Dulles Corridor Metrorail Project

**Review of
Large Bore Tunnel
Engineering and Environmental Studies
from Tysons Tunnel, Inc.
Jan. 22, 2007**

Prepared by Carter & Burgess, Inc.

02/26/2007

Figure 1: Total Cost of Bored Tunnel Elements Versus Advance Rate

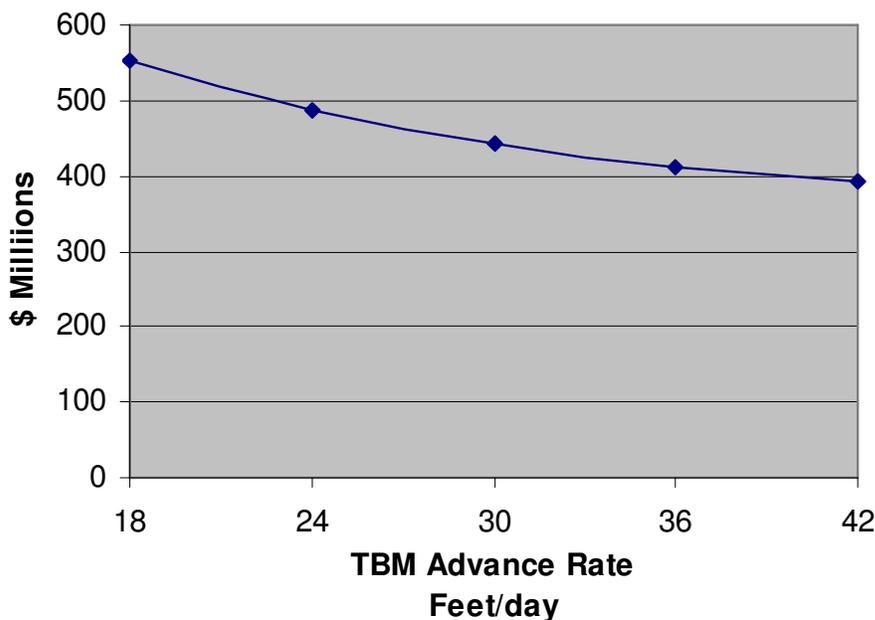
For TBM tunneling the most important factor influencing construction cost is the overall advance rate achieved by the TBM. In order to demonstrate the influence of tunnel advance rate on construction cost, CB developed contractor-style “bottom-up” cost estimates assuming a number of different advance rates. These estimates are based on a 24 hr construction period 5 days/week, with machine maintenance carried out on the weekend, and an overall 30% contingency.

At 32.5 feet/day (the basis for the LBT Proposal) the cost would be \$429.7 million, whereas at 24 ft/day, which is a realistic advance rate for this size machine in ground conditions expected at Tyson’s Corner, the cost would be \$488 million, an increase of 14%. However, based on worldwide large TBM tunnel experience, in particular, the 22-23 feet/day advance rates achieved on the SMART project in Kuala Lumpur, an average advance rate of 24 feet/day is considered more appropriate. It should be noted that these costs do not include escalation due to an approximately 7-month extension of the overall construction duration.
